August 2, 1985
ST-HL-AE-1316
File No.: G4.2

South Texas Project
Units 1 & 2
Docket Nos. STN 50-498, STN 50-499
Meeting Notes from NRC MEB Audit
ASME Documentation Review Portion

- Attachments:
- A. Summary of Results
 - B. Requested Documents
 - C. List of Attendees

CHECKED HLW DATE 10/26/83

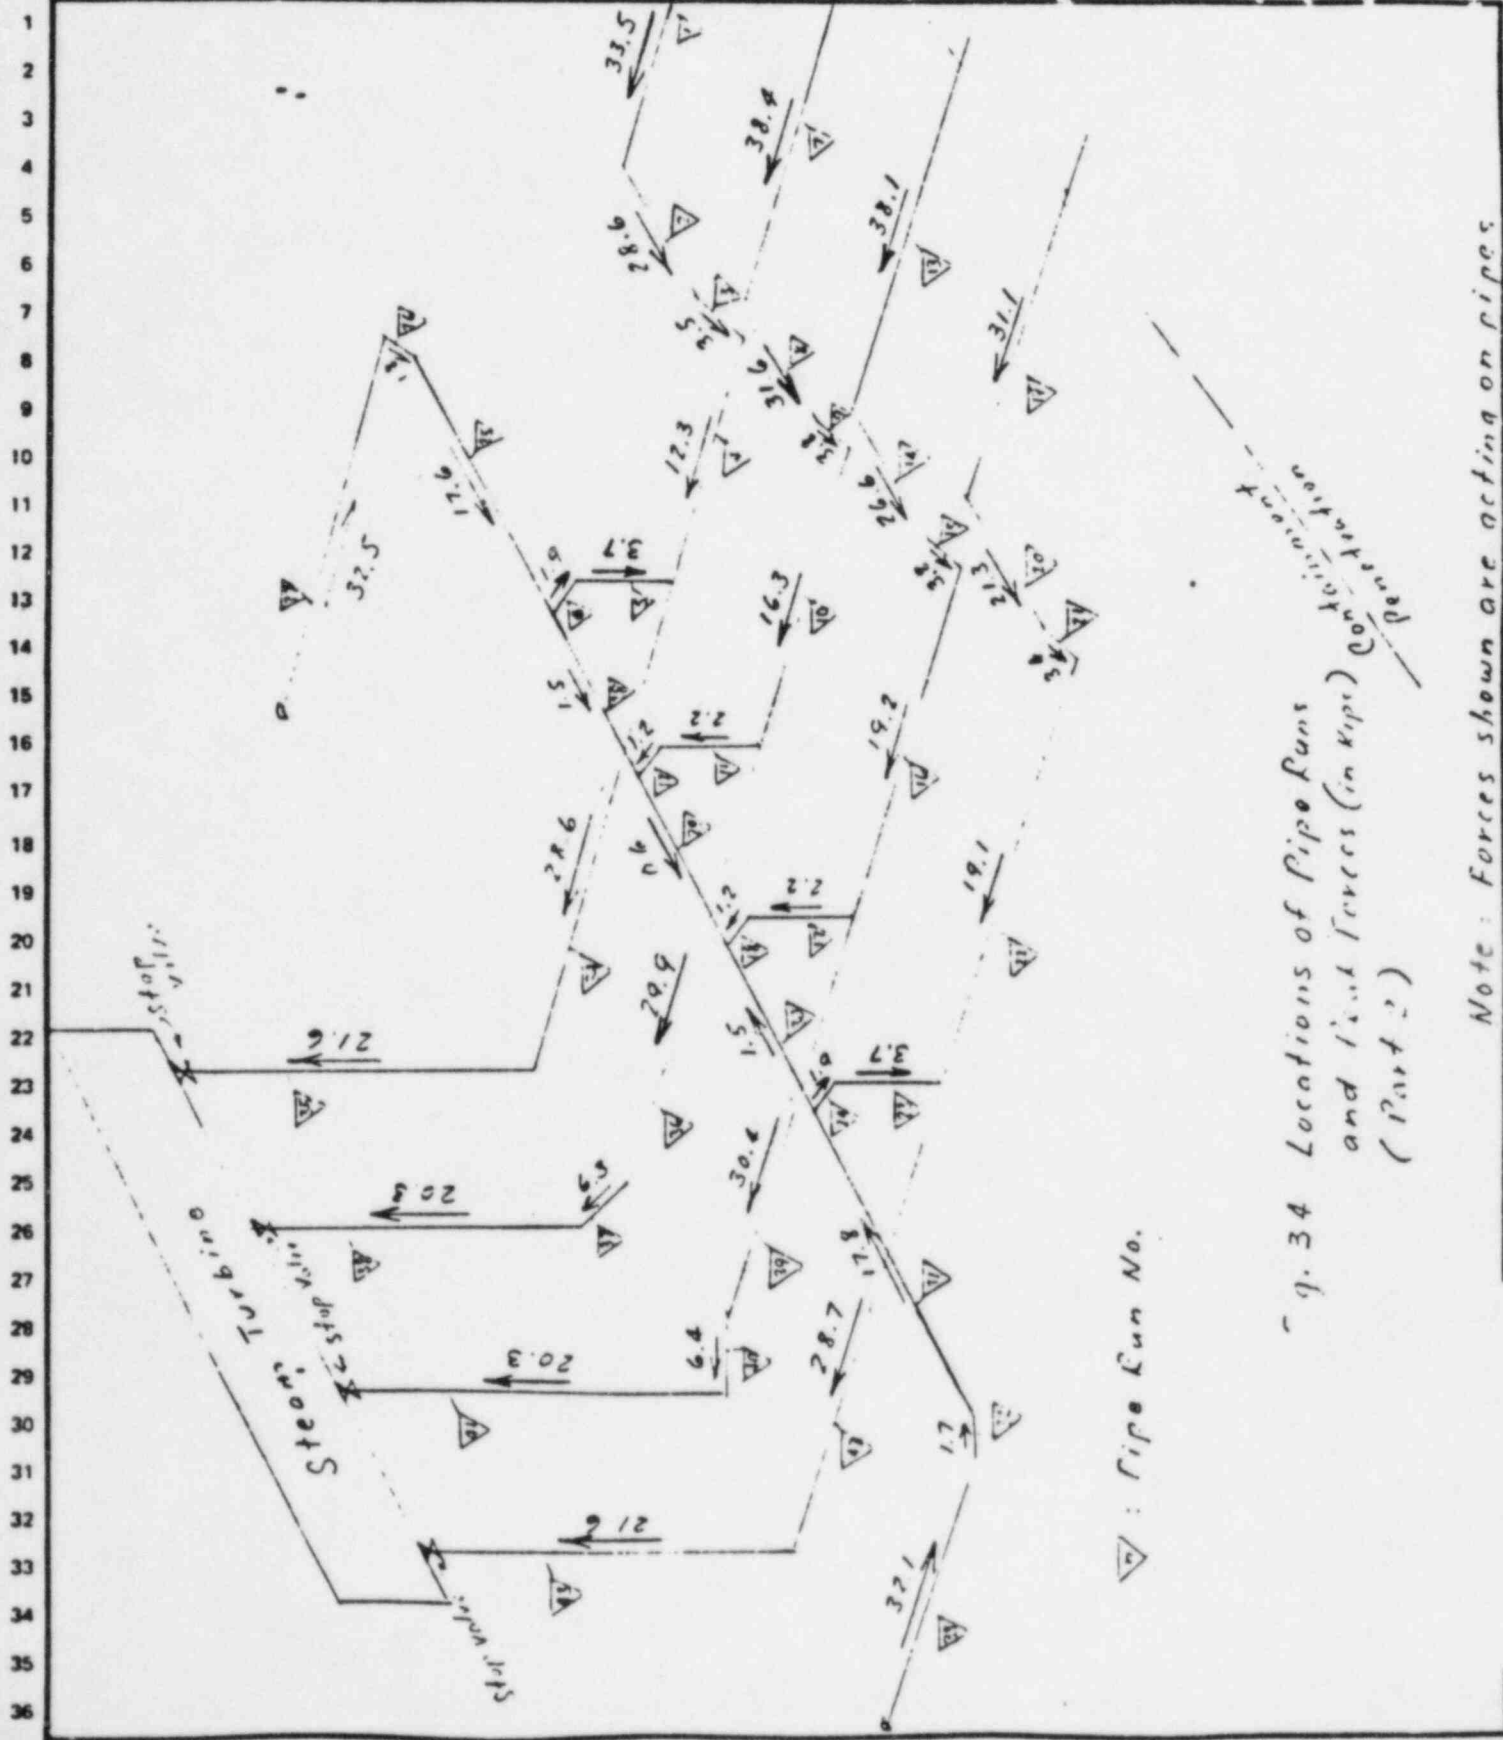
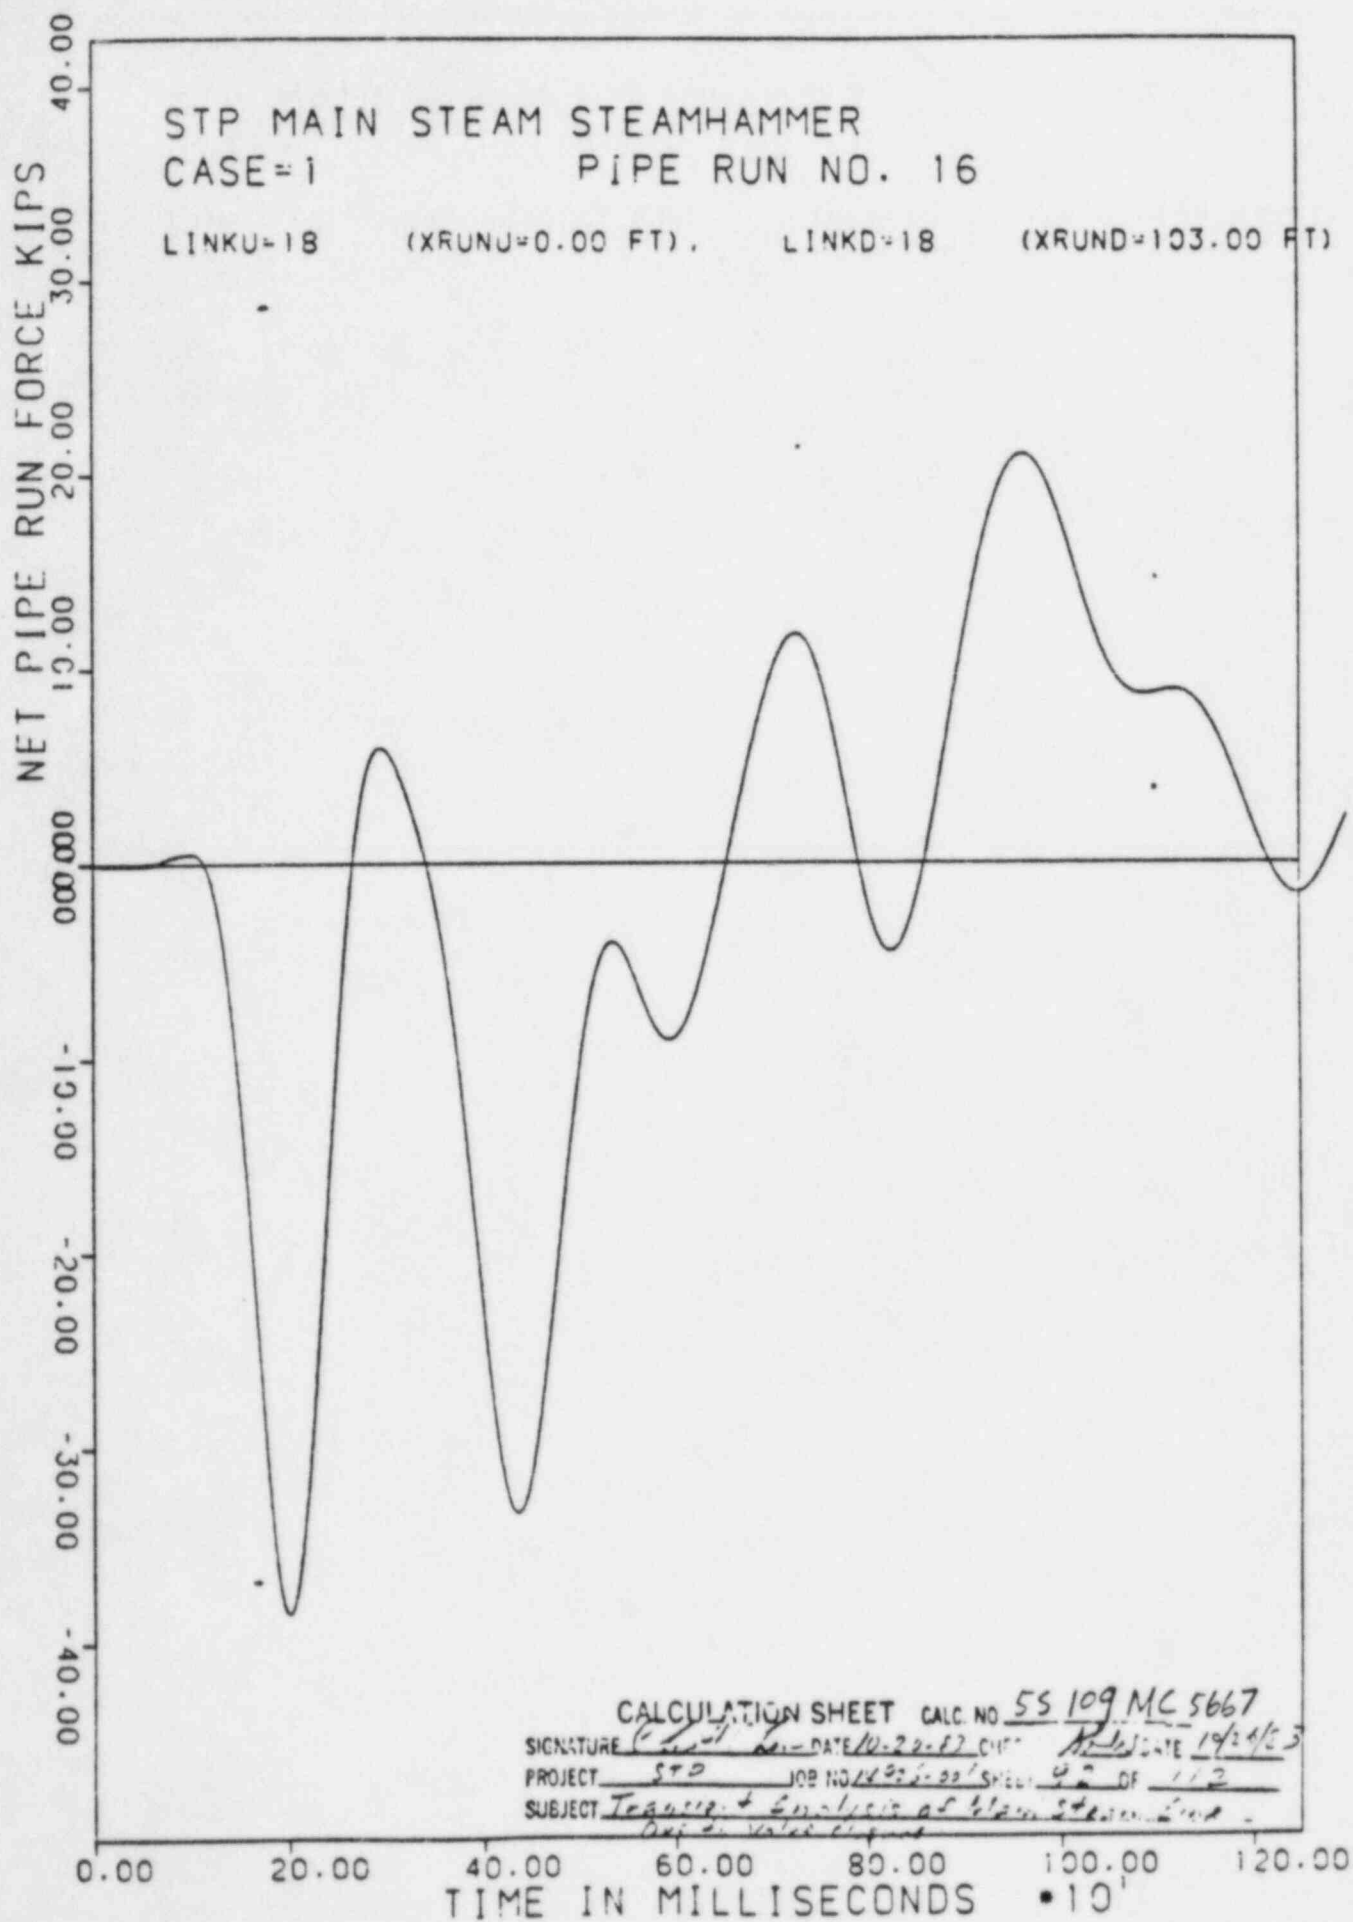
- (a) Does the 1183 psi operating pressure include the pressure wave due to the steam hammer?
- (b) Please describe the steam hammer analysis; e.g., source (turbine trip?), maximum moments and their locations, maximum pressures, support loads. (This may be given in Calculation No. 5N179RC9904; if so, please provide a copy of it.)

- 2. In response to Item (a), it was stated that the 1183 psi operating pressure does not include the pressure wave due to steam hammer.

In response to Item (b), a copy of Calculation No. 5N179RC9904 without appendices was provided. A hand calculation showing the maximum pressure caused by steam hammer was also provided.

20

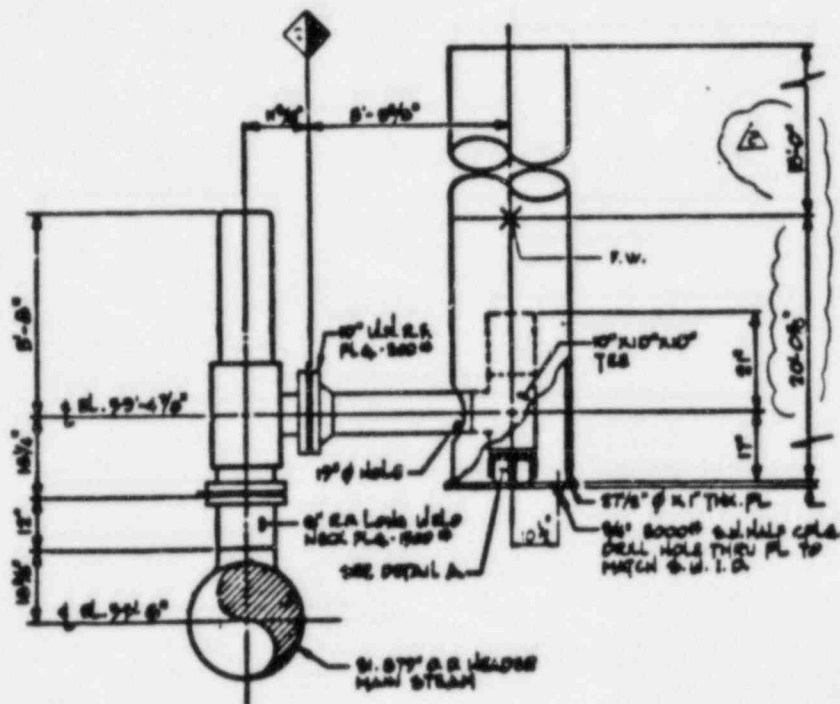
4. Please provide a copy of those portions of the main steam piping analyses which show that the safety valve thrust of 27,000 lb has been evaluated.

4. A copy of sheet 20 of calculation RC6548 was provided. A copy of Drawing No. 5G369PMS646, sheet 3 was provided. A copy of the preliminary calculation for transient loads (RC9966) was provided.
